16010859-ETD/POL 11-1387A

**Study for the EirGrid East-West Interconnector
high voltage DC 200 kV land cables**

An independent assessment

By order of EirGrid and Rush Community Council

Figure 7: Touch voltage difference as a function of the distance to the location of the short circuit.

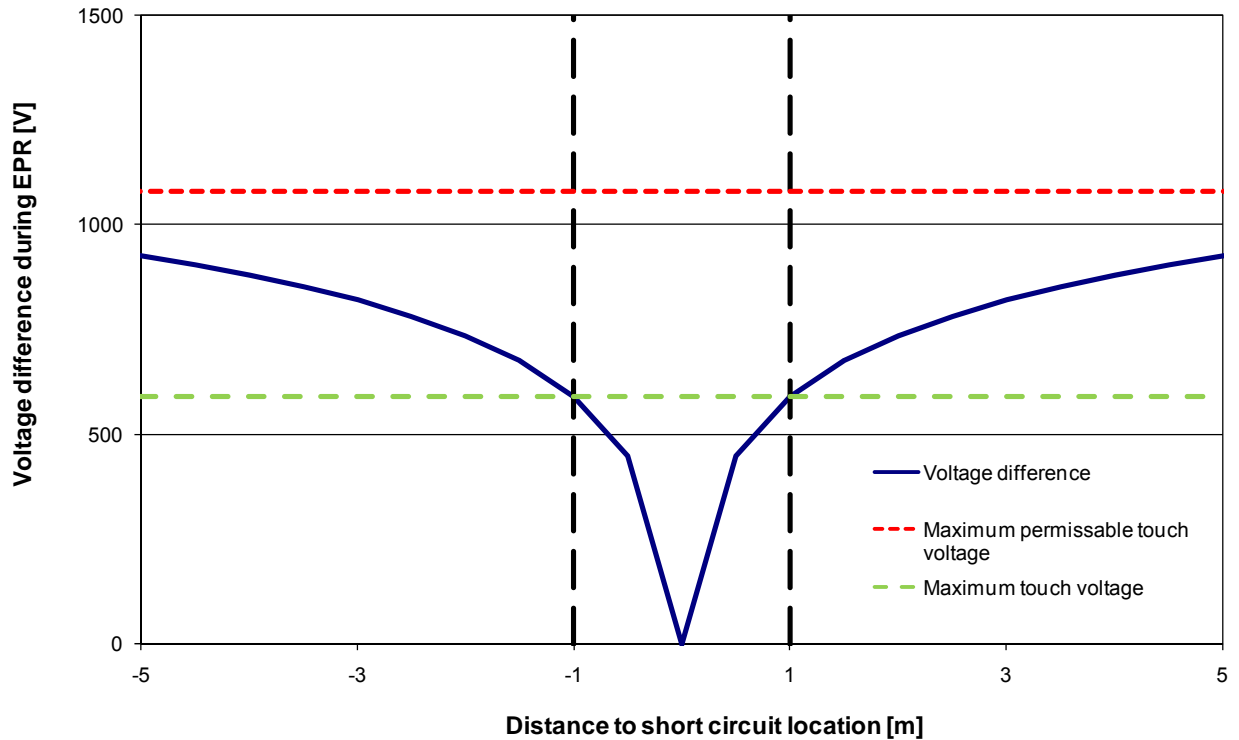
Figure 7 shows that the touch voltage, which is highest at 1 meter from the location of the short circuit (refer to section 5.1), is maximal 590 V. This touch voltage is lower than the maximum permissible touch voltage of 1080 V. Therefore, also the touch voltage meets the requirements stated in the governing NEN-EN 50522, IEEE 80-2000 and IEC 60479-1 standards.

Figure 9: The magnetic field above the HVDC bipole cable circuit in micro Tesla, as a function of the cable depth (vertical distance) and horizontal position.

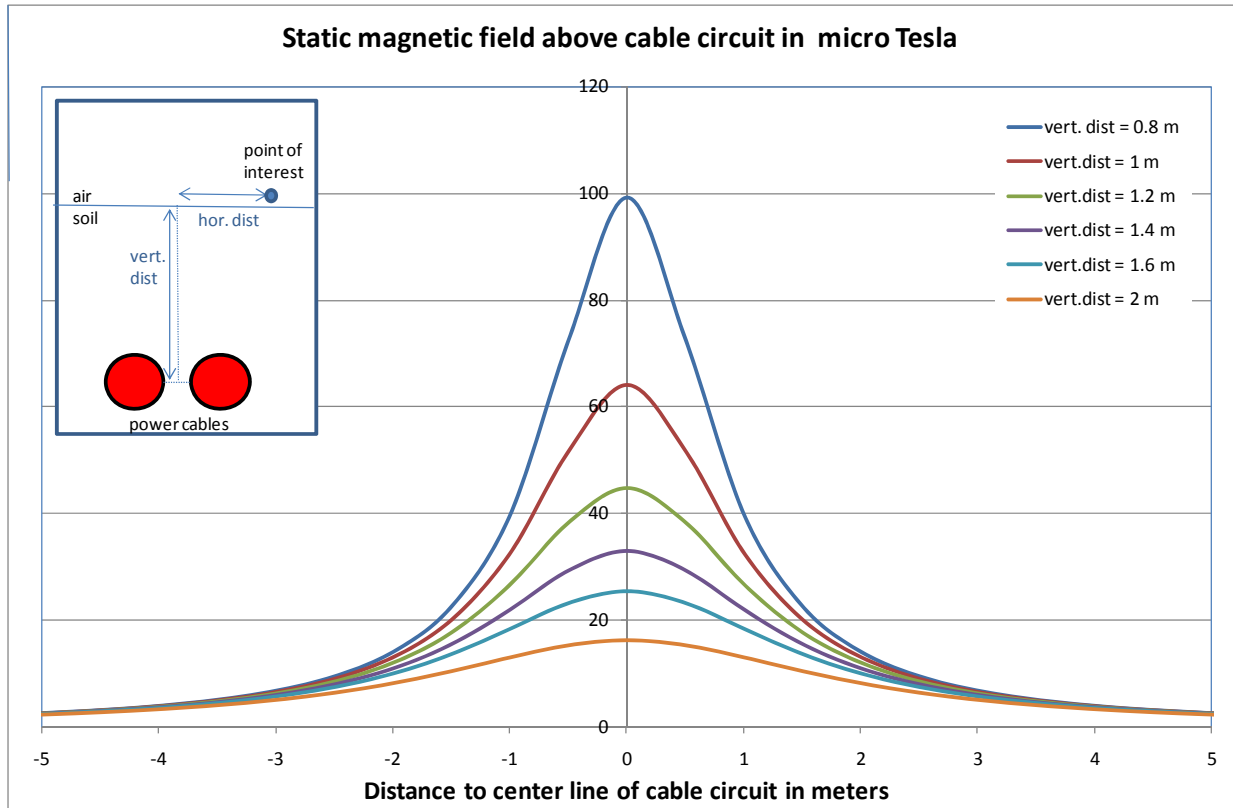
Typically, the burial depth of the cables in the town of Rush is more than 1 meter, the shallowest burial is ~0.9 meters. Houses and other buildings are typically a few meters away. The closest house has a distance of ~1.5 meters from the center of the cable circuit.

Compared to the limitations given by ICNIRP, the static magnetic fields which can be expected on the surface level are much lower than the limitations. Furthermore, the magnetic flux density of 60 μT is also much lower than the value of 500 μT mentioned by ICNIRP as the restriction levels per IEC for people with implanted electronic / ferromagnetic medical devices. Note that the ICNIRP restriction level for people without implanted medical devices is 400.000 μT (400 milli Tesla).

Figure 10: 90 degree bend in the cable at Skerries road en Kilbush lane.

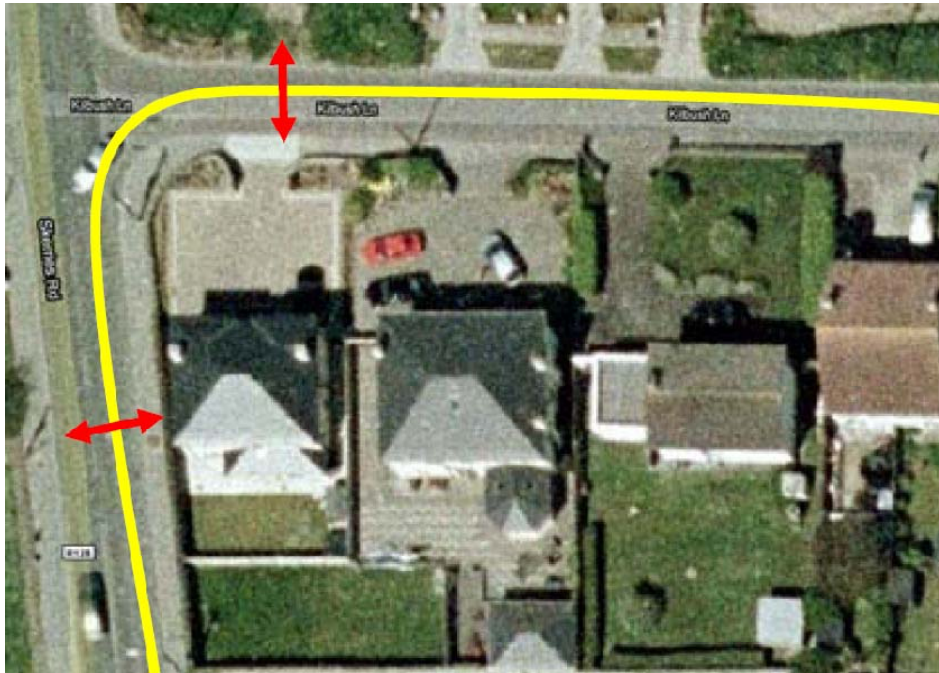
In the case of a bend in the cable route, the magnetic flux density might be increased due to superposition of different magnetic field contributions. In the town of Rush, the situation shown in Figure 10 is present showing a near 90 degree bend in the cable. At a certain point near the cable, there will be a magnetic field contribution due to both the horizontal and the vertical sections of the cable route. However, as the bending radius of the cable has the same order of

magnitude as the magnetic field curve shown in Figure 9, KEMA expects the total increase of the magnetic fields due to the bends will be small. The top values will remain as stated in Figure 9, while one of the slow decaying ‘shoulders’ of the curve will be lifted with a value of maximally a few micro Tesla.
